**DECISION No 14/2021  
OF THE EUROPEAN UNION AGENCY  
FOR THE COOPERATION OF ENERGY REGULATORS**

**of 3 November 2021**

**on the long-term capacity calculation methodology  
of the Core capacity calculation region**

Figure 1: ACER's experimentation: comparison of Core NTC-based yearly auctions from 2020 with simulated flow-based yearly auctions with the same network security level

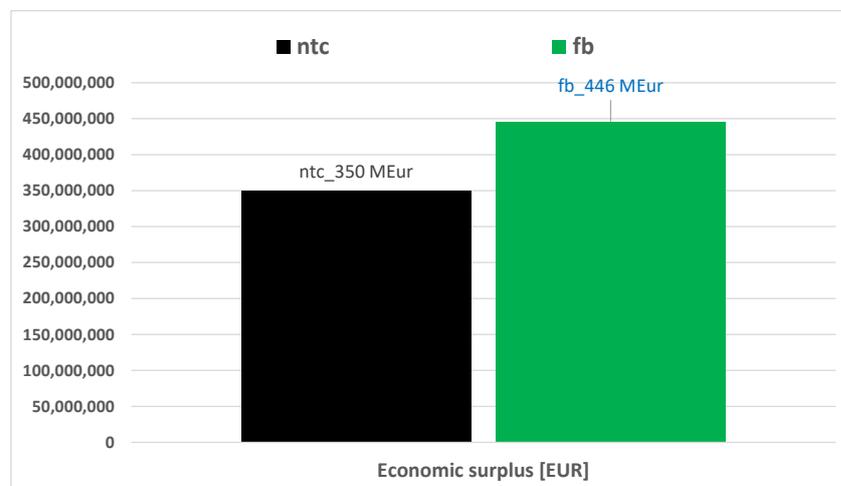
- (iii) The outcomes of yearly NTC-based auctions from 2020 (data marked with ‘ntc’ in the Figure 1) were compared with the simulated flow-based yearly auctions (data marked with ‘fb’ in the Figure 1) with the same bids from the realised yearly auctions. At the ‘fb’ auctions, the calculated flow-based parameters were adjusted with the minimum RAM which reflects the NTC values applied at the yearly auctions, thus providing the same level of system security for both the currently applied NTC approach and the proposed flow-based approach;

- (iv) The simulations have shown that the application of the flow-based approach increases economic efficiency in the Core CCR (characterised by highly meshed network and physically interdependent bidding zone borders) while maintaining the same level of system security. In such circumstances, the flow-based auctions (‘fb’) provide a 27% higher economic surplus (increase from 350 million EUR to 446 million EUR).

Figure 2: ACER’s experimentation: comparison of Core NTC-based yearly auctions from 2020 with simulated flow-based yearly auctions with different level of minimum RAM

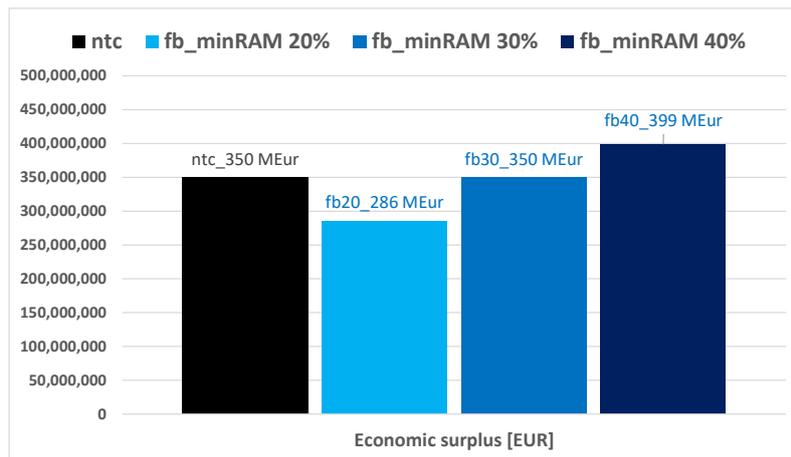
- (a) The results of the experimentation are illustrated in Figure 2, and present the outcomes of flow-based auctions with minimum RAM levels of 20%, 30% and 40% at the yearly flow-based auctions. The auctions with 30% of  $F_{max}$  provide similar economic surplus as the realised yearly NTC auctions for 2020, along with lower allocated quantities<sup>17</sup>;

- (110) On the basis of discussions during the proceedings, applied simulations, and the need to ensure offered capacities at both yearly and monthly time frame, ACER has amended Article 14 of the Proposal by providing the minimal values of minimum RAM at the level of 20% of Fmax for yearly auctions and 10% of Fmax for monthly auctions.
